DOCUMENTATION OF PUBLIC MEETING #2

Pullen Arts Center Improvements Project

Pullen Arts Center Improvements Project – 01.12.2016 Public Meeting #2

Plaza Concept #2

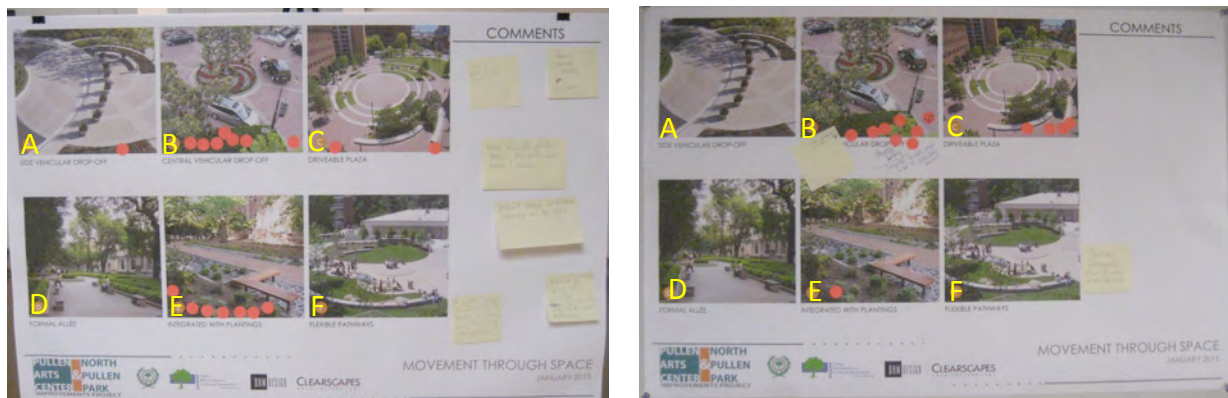
- The entire area is a park already. Theater, gallery, craft are not exclusive. All can use.
- Everyone can use the exterior space even if not going inside a building. Should be a priority equal to the building itself.

- Keep the green gathering space – it's a necessary resting space – spiritually and visually.
- I like preserving a large car free gathering space.
- I think the drop off circle is best for the theater and doesn't require the through road.

- A larger drop-off circle (probably w/landscaping in the middle) would be beneficial so drop-off could be closer to doors.
- I think the circular drop off works better to get carts close to the door.

- I like plaza concept #2, with hardscape above and entry to both upper buildings.
Consider amphitheater – like transition down to lower elevations. Please build in strong pedestrian connection to the Gregg.

- Keep vehicles to perimeter as much as possible.
- Please honor the lobby entry to TIP.
- To meet TIP needs but keep mainly pedestrian, can't there be a small one way road right in front of TIP?

- Seems like adding a gathering space does honor and enhance the entry to the theatre?
- If you have to keep that "Cedar Circle" use it for "gathering space".

- Have the "gathering space" in the front yard of Pullen Arts.
- Maybe smaller gathering space since more people talked about facility and parking use.
- Safety in and out. My main concern is ventilation, access – handicap.

- Add courtyard with bamboo, like Cedar Creek Center.
- Fountain. Water option.
- Picnic tables, comfortable seating, water feature – fountain, raised beds with flowers.

- Put the money in the Arts Center, not a fountain.
- No fountain in the middle - generic.
- Fountain = mosquitoes? No standing water.
